**BOARD OF ZONING ADJUSTMENT
STAFF REPORT****Date: March 2, 2015****CASE NUMBER**

5953

Jerry Arnold (Don Williams, Agent)

LOCATION103 North Warren Street
(Northwest corner of North Warren Street and St. Michael Street)**VARIANCE REQUEST****BULK SITE:** Bulk Site Variances to allow a wooden surfaced terrace to occupy 26% of the primary frontage on North Warren Street, a 12" high terrace for outdoor seating, and allow a metal canopy in the Downtown Development District.**ZONING ORDINANCE
REQUIREMENT****BULK SITE:** The Zoning Ordinance requires a terrace to occupy 100% of the building façade except where driveways are permitted, terraces must be paved or landscaped with a minimum of 20" high terrace for outdoor seating, and does not allow metal canopies in the Downtown Development District.**ZONING**

SITE PLAN

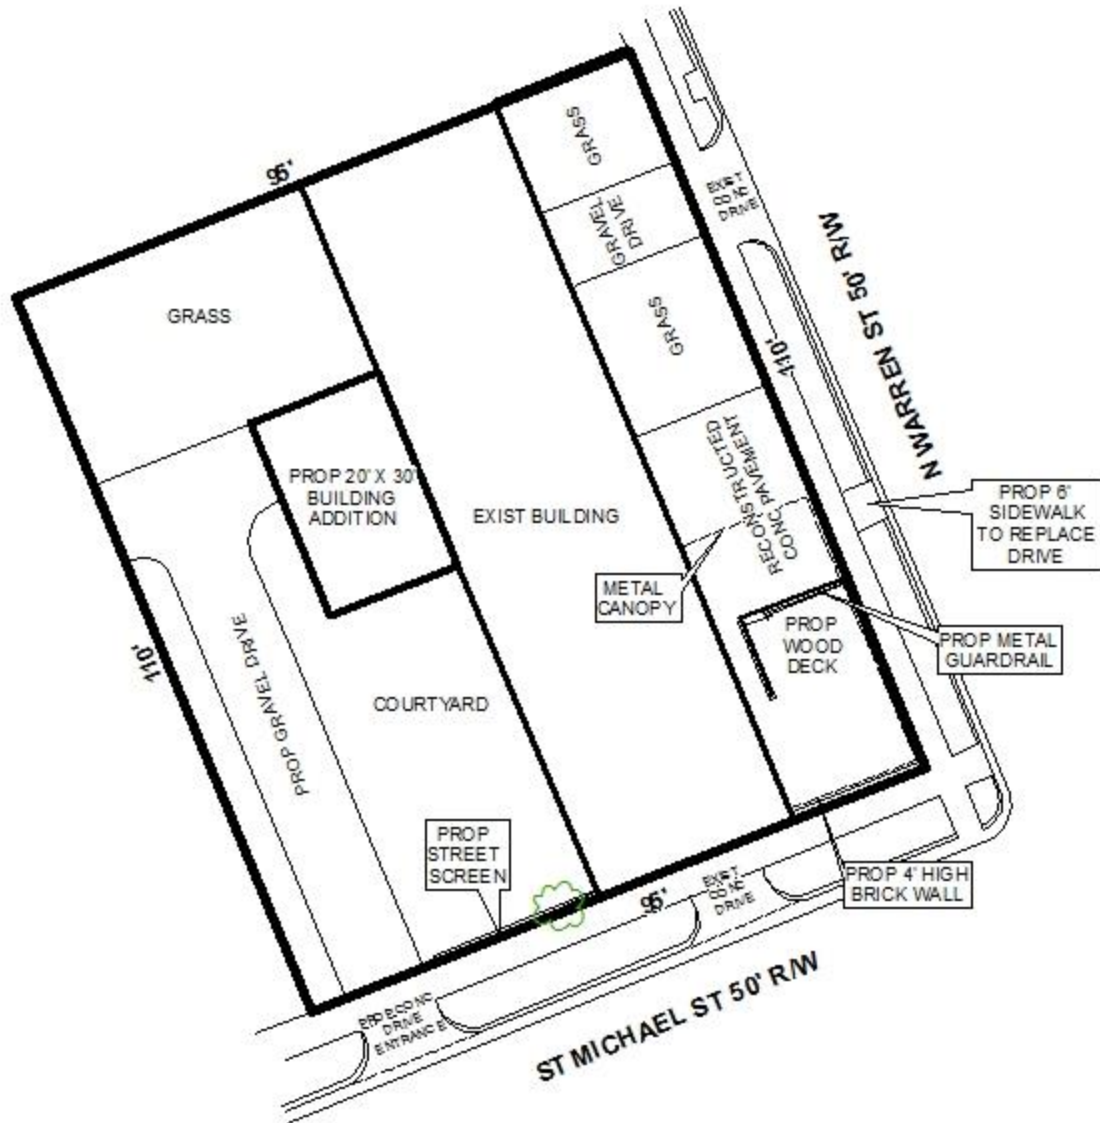
The Zoning Ordinance allows for a site within the Downtown Development District to have one curb-cut per street frontage. It should be noted that the proposed site plan illustrates an existing gravel driveway along North Warren Street, a proposed gravel driveway for grain delivery along St. Michael Street, and an existing concrete drive entrance along St. Michael Street. The existing

concrete drive along St. Michael should be removed, and replaced with landscaping and curbing, or a new variance application should be submitted.

The primary entrance of a structure in the Downtown Development District shall be through the façade, parallel to the primary frontage. The applicant has identified North Warren Street as the intended primary frontage, therefore it should be noted that one of the two illustrated doors along North Warren Street shall be the primary entrance to the structure.

A site developed with a terrace frontage, such as proposed by the applicant, requires a raised terrace between 20 and 36 inches above sidewalk grade to occupy 100% of the width of the façade at the primary frontage (except where driveways are permitted), and shall be paved or landscaped. The proposed site plan illustrates a 12" high terrace that will occupy 24.5% of the width of the faced at the primary frontage. The applicant mentions that a terrace constructed to the required minimum height would require a long ramp that would not fit on the subject site, however, there is no mention of a ramp being required on the outside of the structure to access the terrace. Furthermore, there is no justification provided as to why a terrace is not proposed along the entire façade, except for the driveway, as required, nor why a paved or landscaped terrace is not an acceptable option.

The proposed site plan illustrates a proposed metal canopy over the proposed terrace, extending 13' along the façade of the structure (38% overall). A site with a terrace frontage is not required to have an awning; however, should the applicant wish to have an awning, it must be fabric, not extend beyond the terrace, and shall span a minimum of 80% of the frontage. The applicant states that a fabric awning of the proposed size "could not reasonably" meet building code standards for windloads, however no supporting evidence is provided. While that may be true, the applicant could use several smaller awnings which would be able to meet all building code requirements. It should be noted all awnings require a minimum clearance of 8' above the terrace level.

There are several pieces of information missing, which makes it difficult for staff to determine if the site will fully comply with the Zoning Ordinance in the Downtown Development District. No information is provided by the applicant regarding how waste will be handled. If a dumpster is proposed for the site, a revised site plan illustrating a dumpster in compliance with Section 64-3.I.12. of the Zoning Ordinance will be necessary. Also not illustrated on the site plan, is the location of the proposed HVAC system, electric meters, gas meters, and water meters, which are to not to be located along any frontage. There is also no mention of what material the proposed exterior façade will consist of, nor the proposed roof slope of the existing building, the proposed addition, or the proposed metal awning.

RECOMMENDATION: Based on the preceding, staff recommends to the Board the following findings of fact for Denial:

- 1) Approving the variance will be contrary to the public interest due to the fact that it will deviate from the recently adopted Downtown Development District Code and Regulating Plan, which intends to guide building siting and form to vary by context and intensity in coordination with community identity and preferences;

- 2) Special conditions do not exist with this site such that a literal enforcement of the provisions of the chapter will result in unnecessary hardship, as the site could be developed with a compliant frontage type allowed in the Special District – Warehouse sub-district; and

- 3) That the spirit of the chapter shall not be observed and substantial justice shall not be done to the applicant and the surrounding neighborhood by granting the variance due to the fact that the requested variances would be out of character with the districts identified in the Regulating Plan created by the recently adopted Downtown Development District Code.

The application is recommended for Holdover until the May 4, 2015 meeting to allow for revisions to be submitted by April 13, 2015.
